**Wichita-Sedgwick County
Metropolitan Area
Planning Department**

Re: BZA2025-00033: Administrative Adjustment in the City to reduce the south rear setback from 20 feet to 16 feet (20 percent) to build a duplex, on property zoned TF-3 Two-Family Residential District, generally located within one-quarter mile south of West Pawnee Avenue and within one-half mile east of South 135th Street West (12801 S. Wheatland Ct).

SITE PLAN

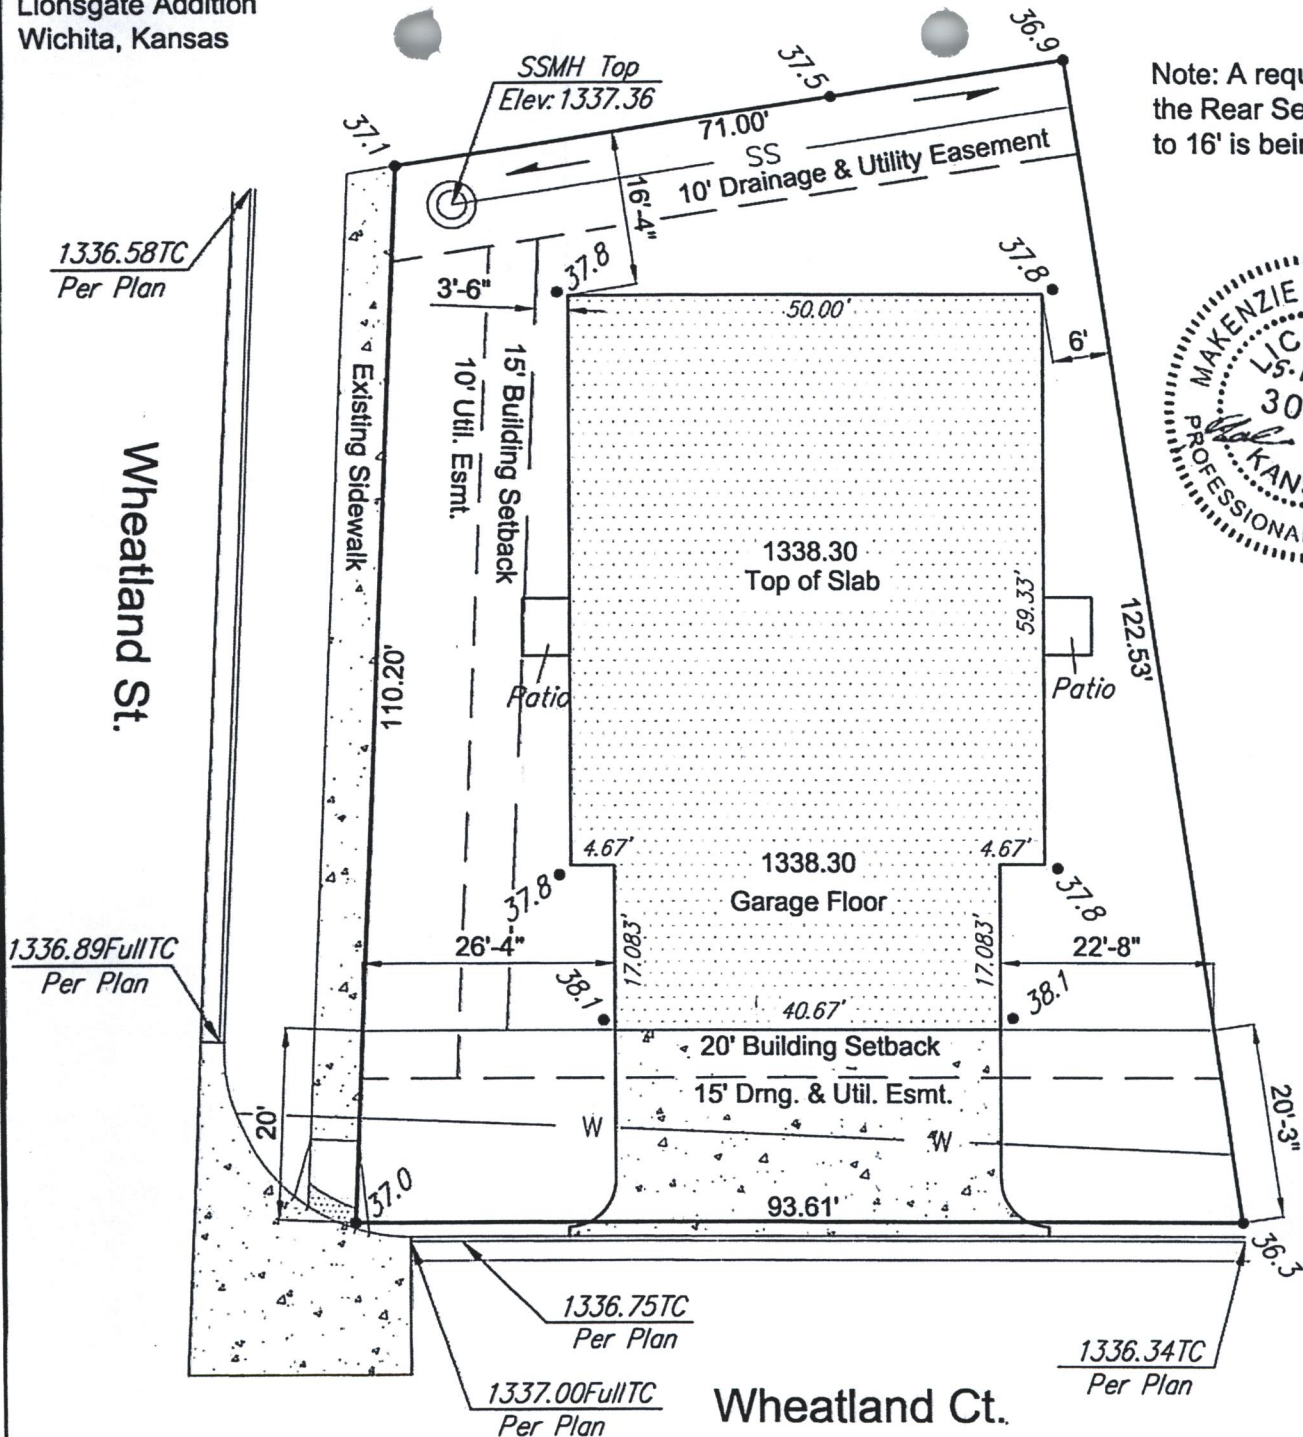
We have reviewed your request for Zoning Adjustments to reduce the south rear setback from 20 feet to 16 feet (20 percent) on the aforementioned property in order to build a duplex. The rear property line angles to the southwest, and only the southeast corner of the proposed duplex would be 16 feet from the rear property line. The distance between the proposed duplex and the rear property becomes greater farther west.

- 2) Impact on existing uses in surrounding areas: There will be no impact on the existing uses. The surrounding properties are all zoned TF-3 and are undeveloped. The proposed duplex would be 16 feet from the rear property line only in the southeast corner. The degree of separation increases to the west.

- 3) The setback reduction shall apply only to the 16-foot south rear setback as illustrated on the approved site plan. All other structures or additions on the subject property shall conform to the setbacks permitted by the Unified Zoning Code unless a separate Zoning Adjustment or Variance is granted.

Our signatures below indicate that the Zoning Adjustment to reduce the south rear setback from 20 feet to 16 feet is hereby GRANTED, subject to the following conditions:

APPROVED 5/21/25 BY [Signature]
BZA 25-33
